Technical Service Bulletin

GROUP CAMPAIGN	NUMBER 16-01-016
DATE APRIL 2016	MODEL(S) GENESIS SEDAN (BH) EQUUS (VI)

SUBJECT: WINDSHIELD WIPER MOTOR COVER REPLACEMENT
(RECALL CAMPAIGN 140)

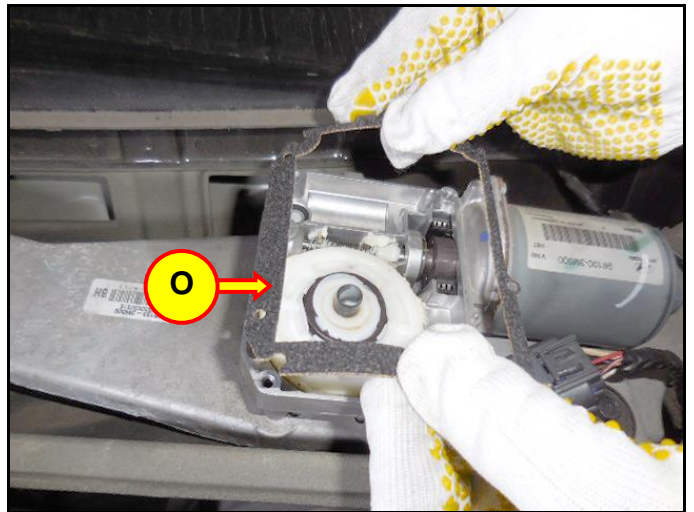
12. Carefully remove the motor cover and seal (N).

13. Place the new seal (O) on the motor.

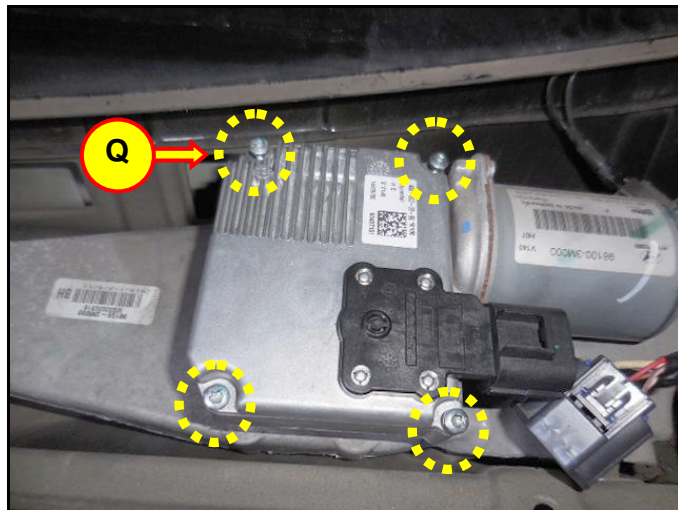
14. Install the new cover (P) and the four new Torx head screws (Q).

Tightening torque:

1.9 ~ 2.9 Nm (0.2 ~0.3 kgf.m, 1.4 ~ 2.1 lb-ft)
